TMI-20-017

Three Mile Island Nuclear Station, Unit 1
Renewed Facility Operating License No. DPR-50
NRC Docket Nos. 50-289

Subject: 2019 Annual Radiological Effluent Release Report

ODCM Change for TMI
Offsite Dose Calculation Manual, Revision 6
CY-TM-170-300

FIGURE 1-1
TMI-1 Liquid Effluent Pathways
Page 1 of 1 [JDMN41]

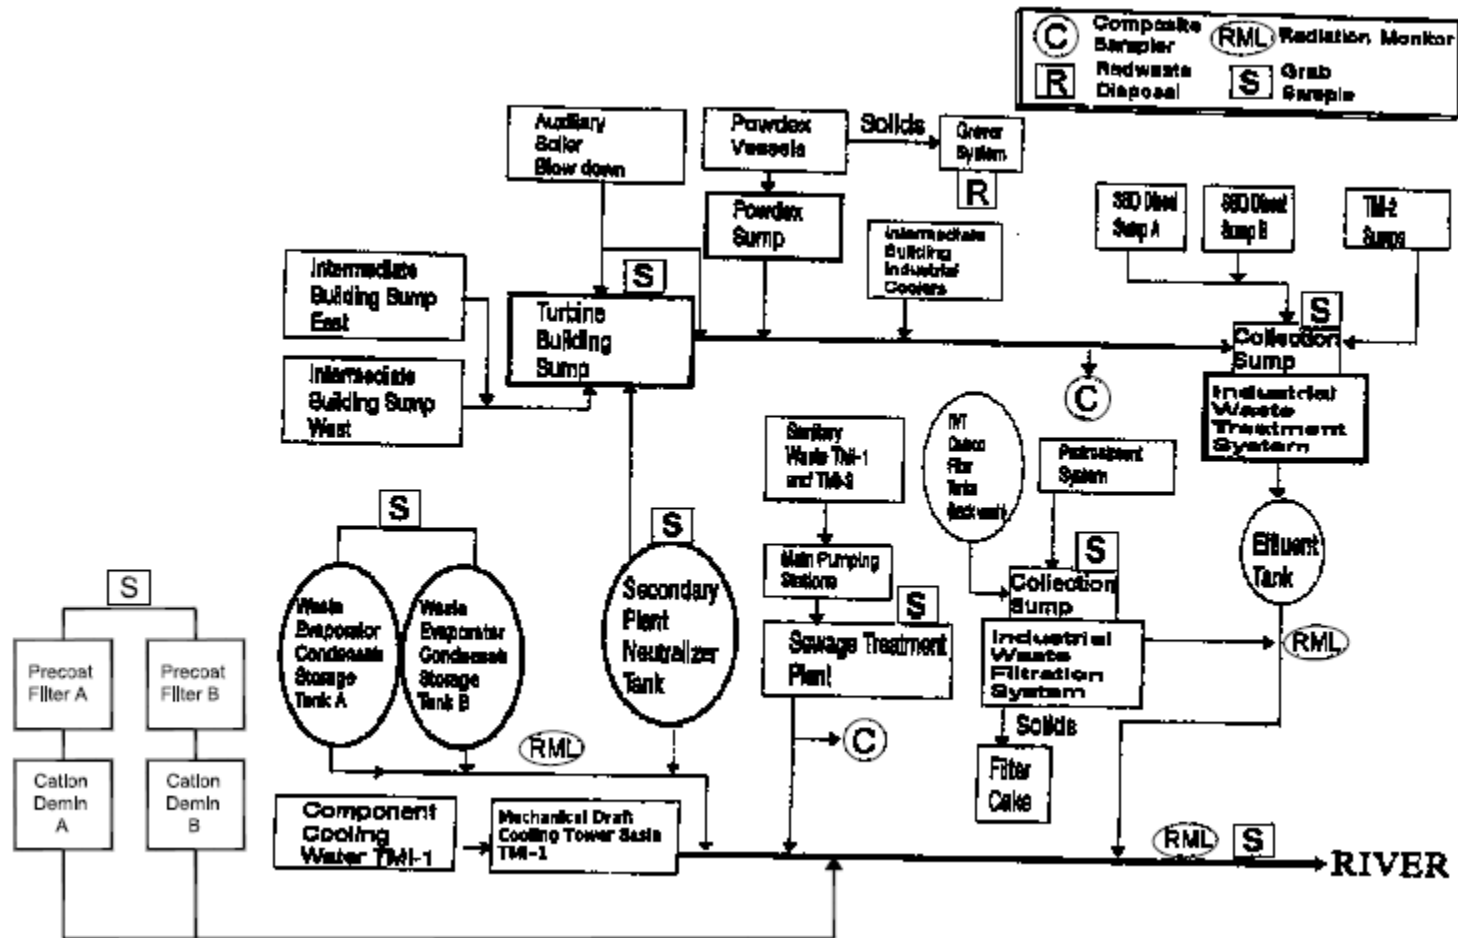
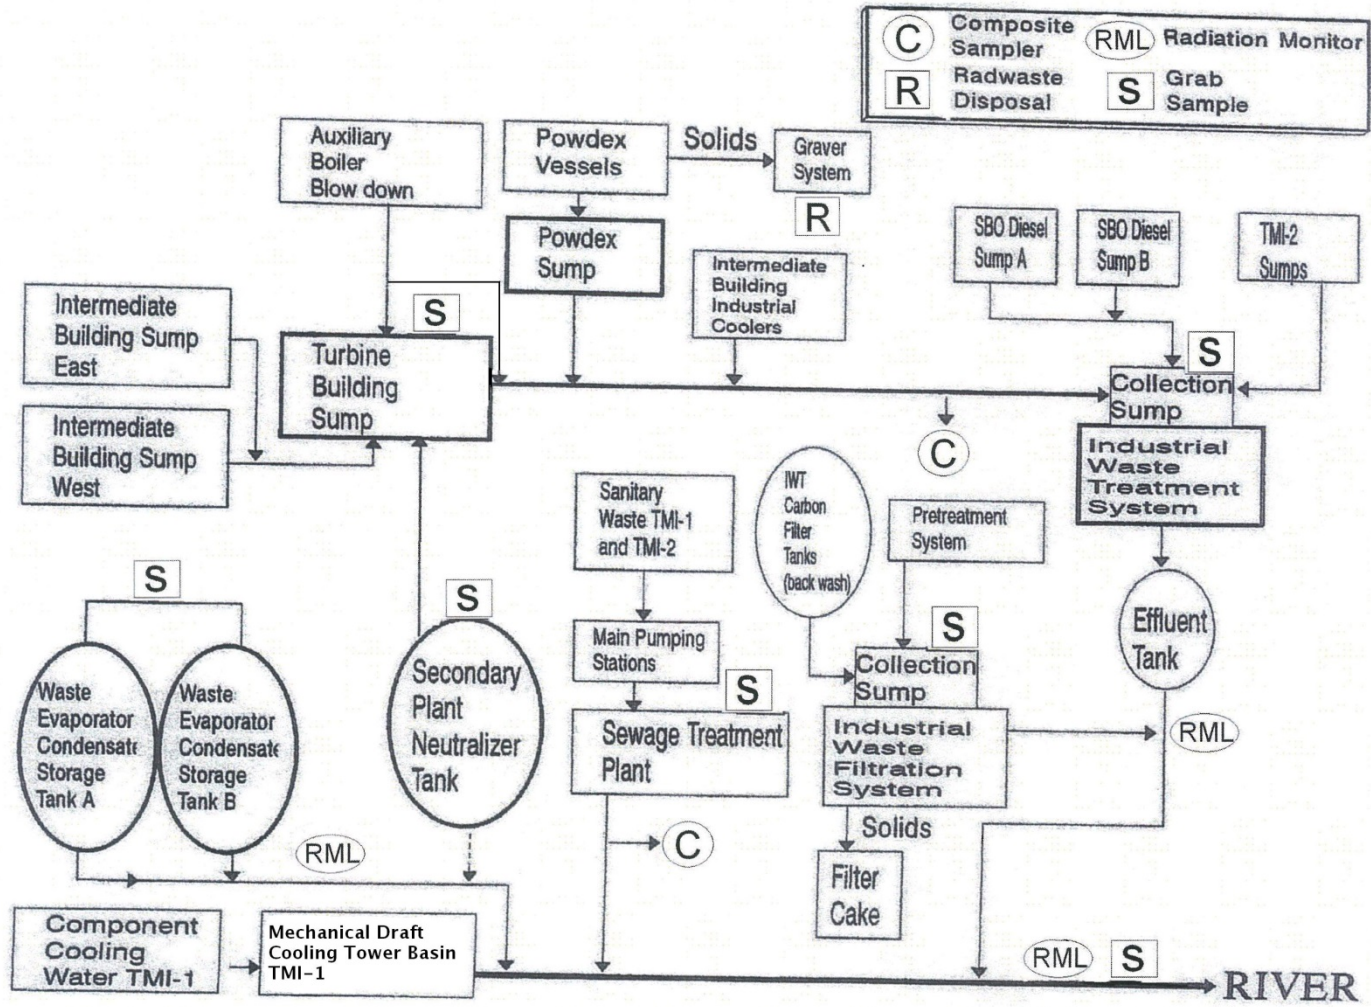
The description of the TMI-1 Liquid Effluent Waste Treatment System” in Section 3.1 and 3.2 of the ODCM is modified. The preferred method of Liquid Radwaste Treatment is modified to use mechanical filtration and demineralizers instead of an evaporator. The new method will use the following existing liquid radwaste treatment equipment: Precoat filter (WDL-F-1A and 1B) and cation demineralizer (WDL-K-2A and 2B).

- a. Water Sources
 - (3) Reactor Coolant Bleed Tanks (RCBT)
 - (1) Reactor Coolant Drain Tank (RCDT)
- b. Liquid Processing [JDMN42]
 - 1. Pre-Coat Filter WDL-F-1A/1B and WDL-K-2A/2B Cation demineralizer
 - OR
 - 2. a) -Reactor Coolant Waste Evaporator
 - b) -Demineralizers prior to release (see Figure 3.2)
- c. Liquid Effluent for Release - (2) Waste Evaporator Condensate Storage Tanks - (WECST)
- d. Dilution
 - Station Effluent Flow
 - River Flow

FIGURE 4.1
TMI-1 Gaseous Effluent Pathways

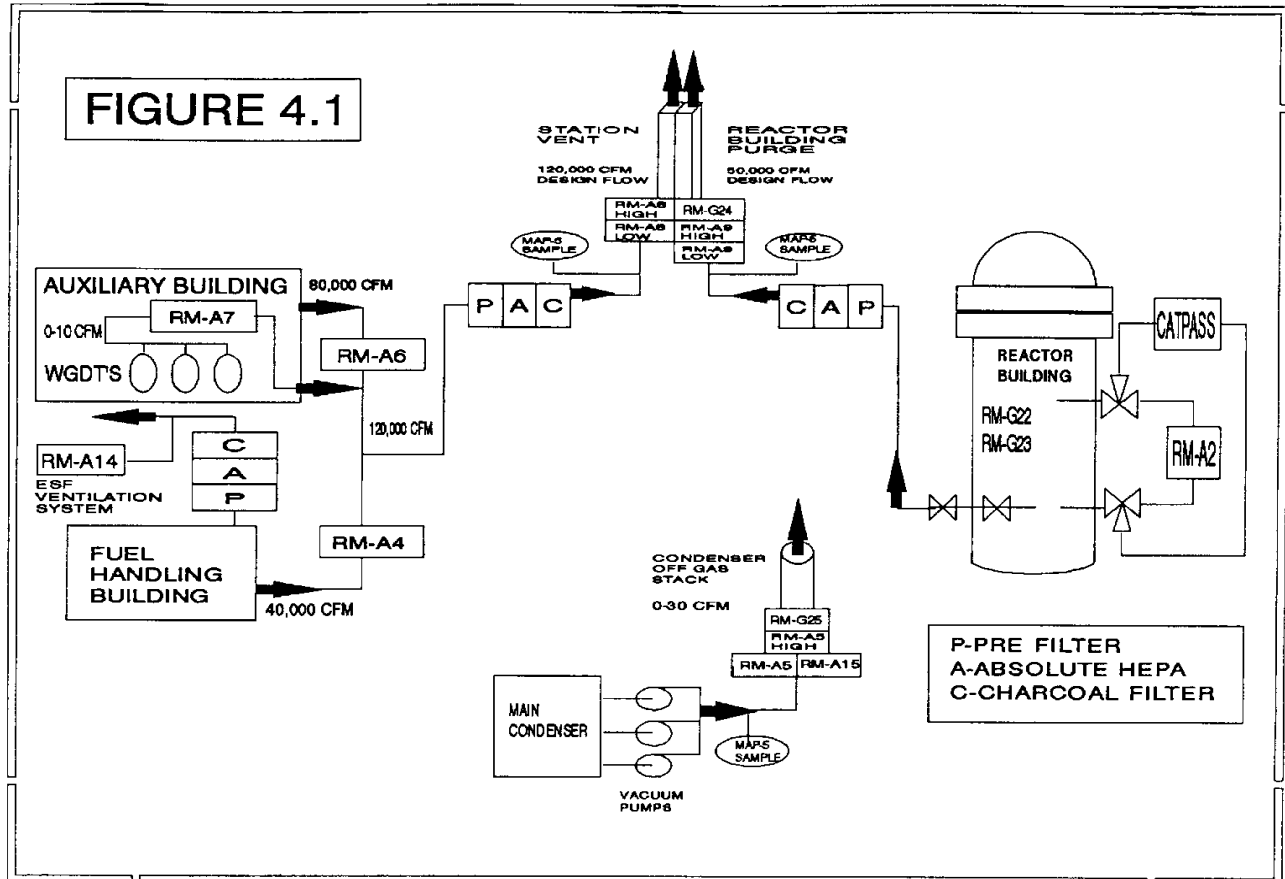
Note: After permanent shutdown, the condenser air removal system will be permanently shut down. After the Post Defueled Tech Specs are implemented, the FHB ESF ventilation system will be permanently shut down. The charcoal filters in the Auxiliary and Fuel Handling Building Ventilation Exhaust (AH-F-2A/H) are not required after the reactor has been shut down for more than 60 days [JDMN51].

FIGURE 4.2
TMI-1 Auxiliary and Fuel Handling Buildings Effluent Pathways

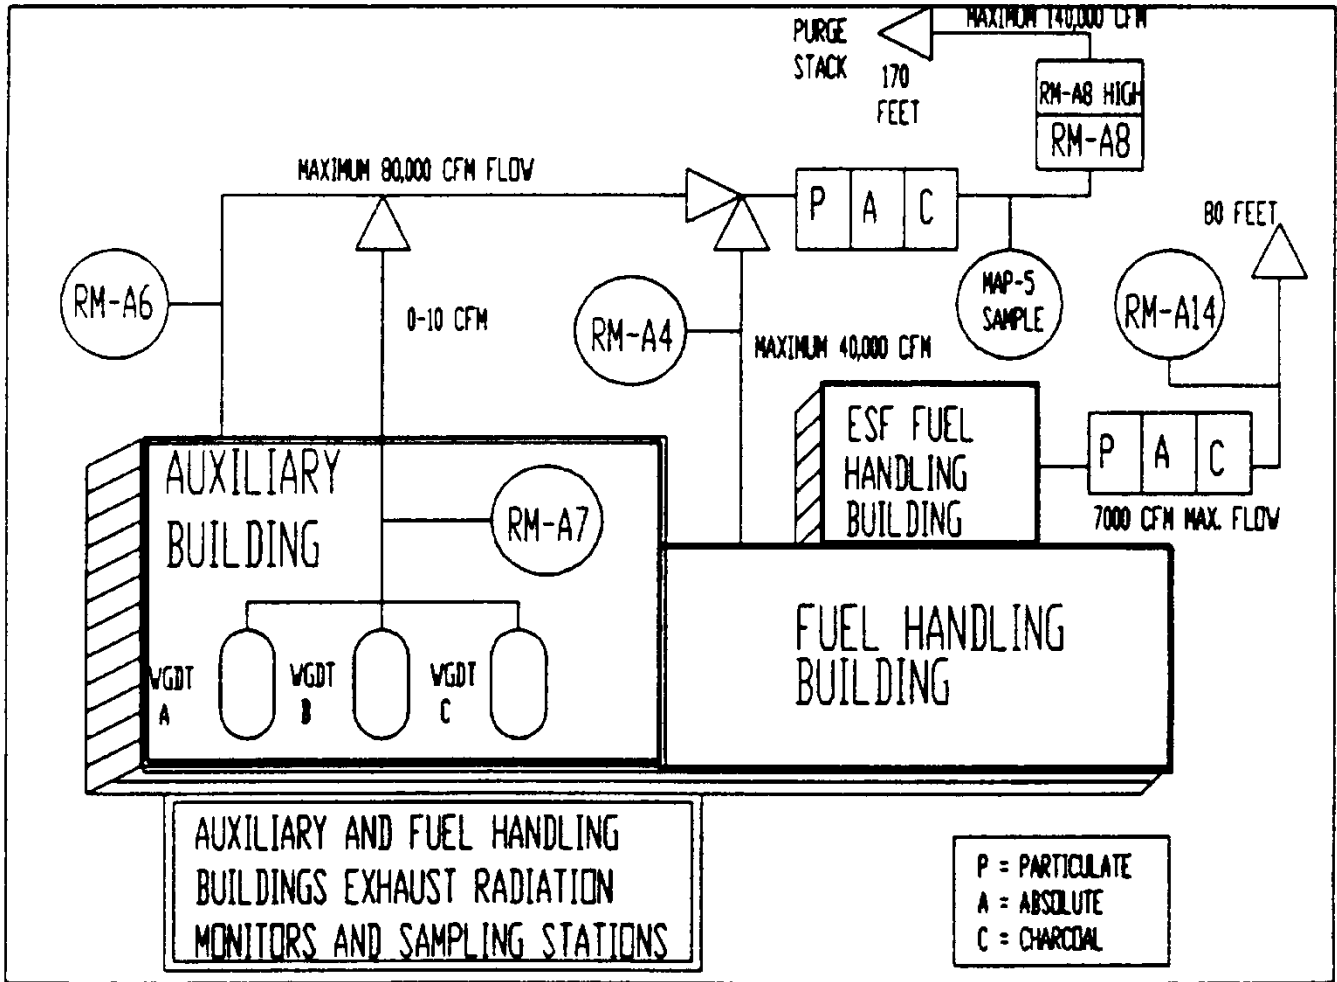
Note: After the Post Defueled Tech Specs are implemented, the FHB ESF ventilation system will be permanently shut down. The charcoal filters in the Auxiliary and Fuel Handling Building Ventilation Exhaust (AH-F-2A/H) are not required after the reactor has been shut down for more than 60 days [JDMN52].

FIGURE 4.4

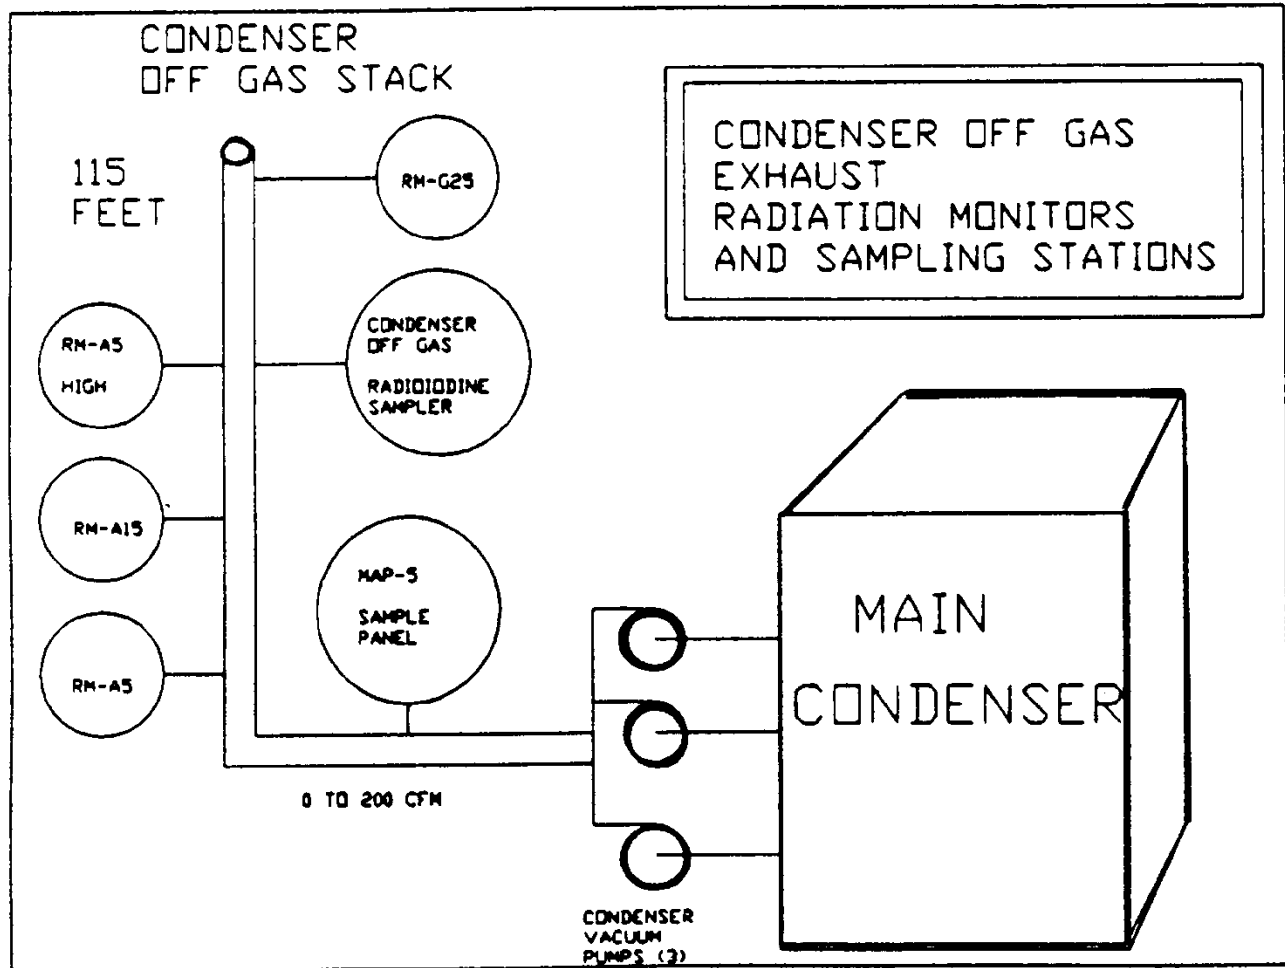
~~TMI-1 Condenser Offgas Effluent Pathway~~ Delete [JDMN53]

FIGURE 6.1
Waste Gas System*

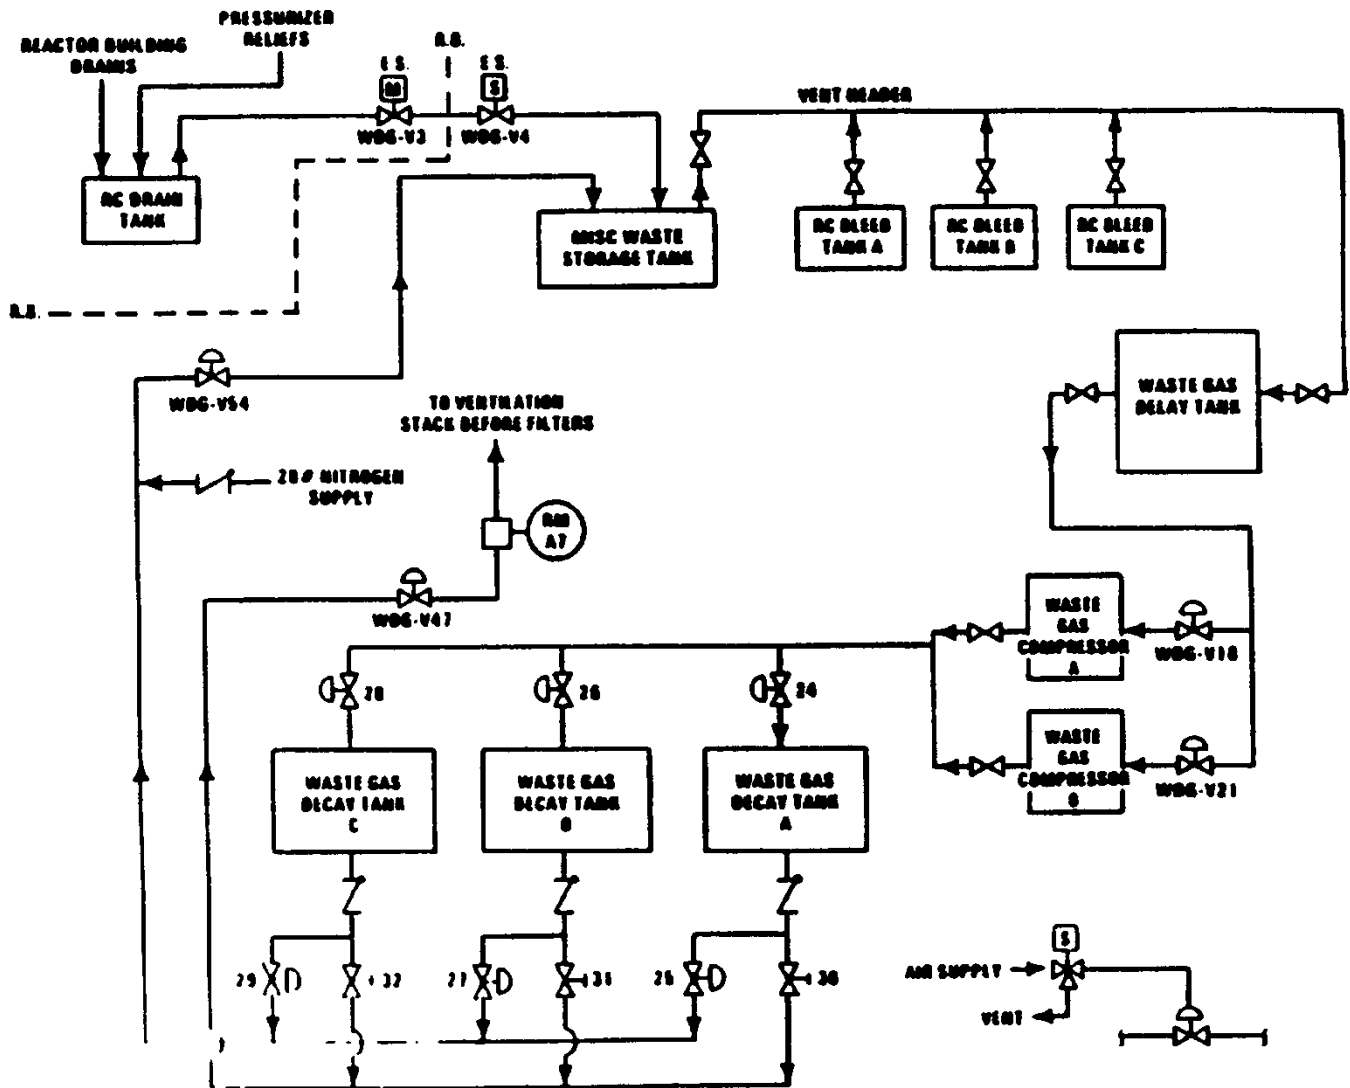
The waste gas vent header can be permanently removed from service when the radioactive gas within the system concentrations could no longer challenge the personnel habitability limits per [10CFR20]JDMN55].
